**REQUEST FOR BID 2869-05A, 2869-05B, 2869-05C, 2869-05D
W 76 Country Blvd Streetscape – Segments 1 and 2**

Addendum No. 2

Addendum NO 2

FOR: W 76 Country Boulevard Streetscape Improvements
Contracts EN7622, SNS0032 &
W 76 Country Blvd Median Improvements
Contracts TAP-9901(886) and STP-0761(023)
GRE Project 4515

UTILITY CHASE - W 76 COUNTRY BLVD.
SHOULDER DETAIL
STA. 98+28.76L - 103+00.29 L
NOT TO SCALE

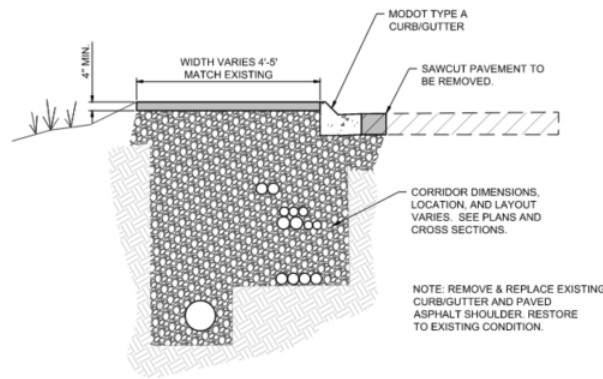
3. 5' Asphalt Paved Shoulder Location is not clear

- See detail Sheet U-03 of 34. This work is to replace the asphalt shoulder over the proposed utility trench North of the Shepherd of the Hills Expressway Intersection.

FLAGSTONE PAVERS 03
N.T.S.

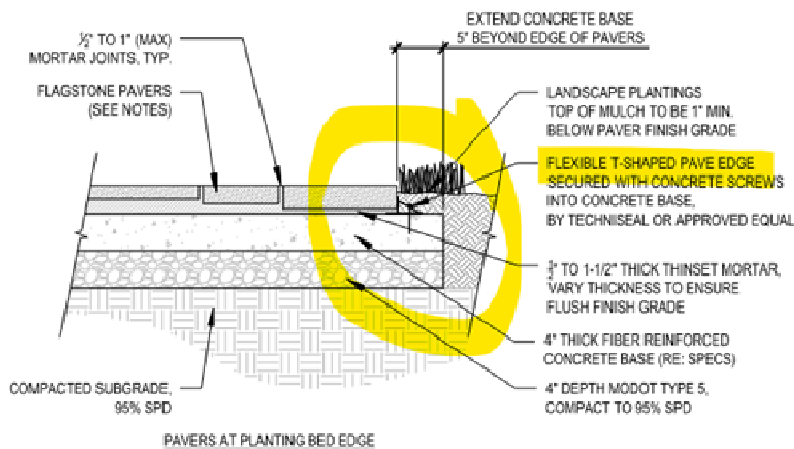
4. Pave Edge Detail Unclear

- Pave Edge is part of the landscape detail anchoring pavers and can be found in the landscaping plans Sheet LP34 of 39.

GROUND ROD SPEC FOR ALL VAULTS
WITH EQUIPMENT SET ON THEM

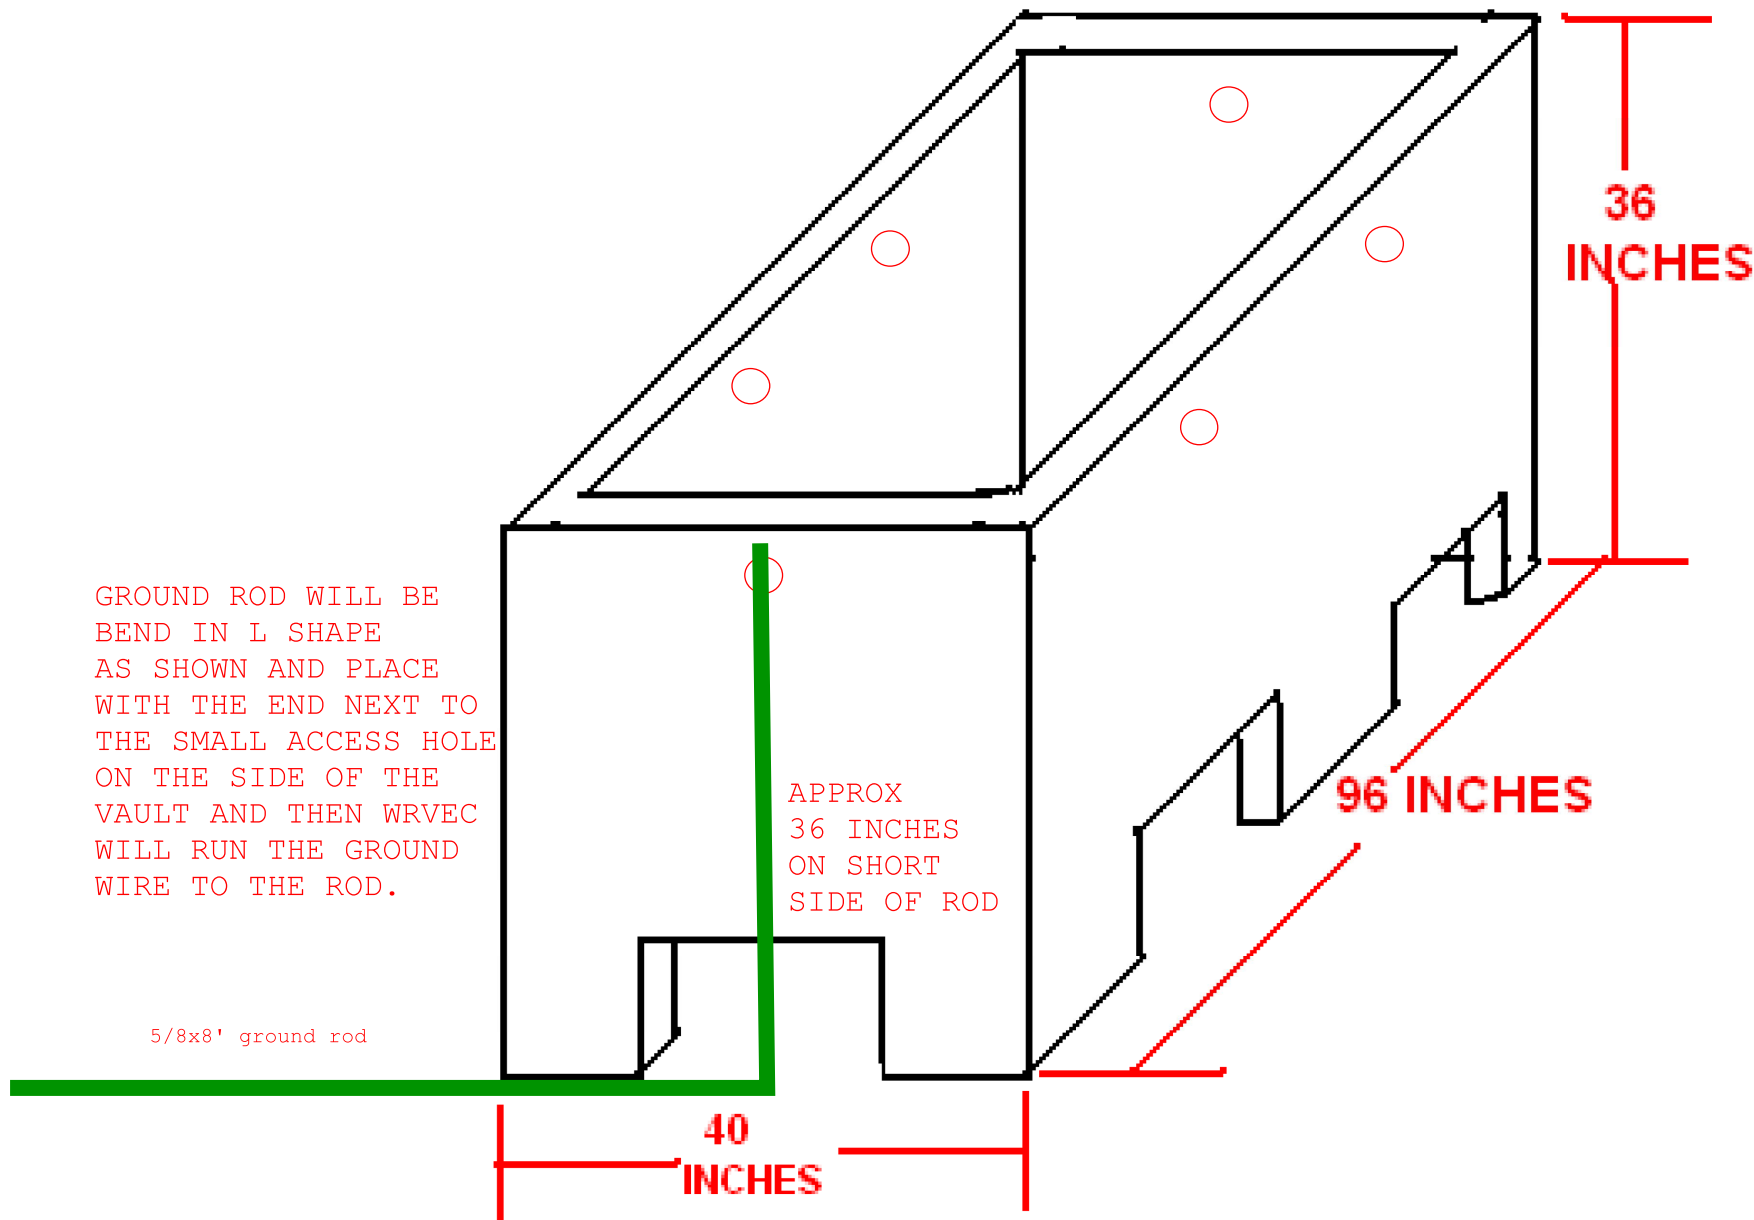
6. Add the attached White River Valley Electric Cooperative detail for ground rod installation for all WRE vault and equipment installation. Installation of the ground rod is considered incidental to vault and equipment installation and no separate payment will be made for the work.

GROUND ROD WILL BE
BEND IN L SHAPE
AS SHOWN AND PLACE
WITH THE END NEXT TO
THE SMALL ACCESS HOLE
ON THE SIDE OF THE
VAULT AND THEN WRVEC
WILL RUN THE GROUND
WIRE TO THE ROD.
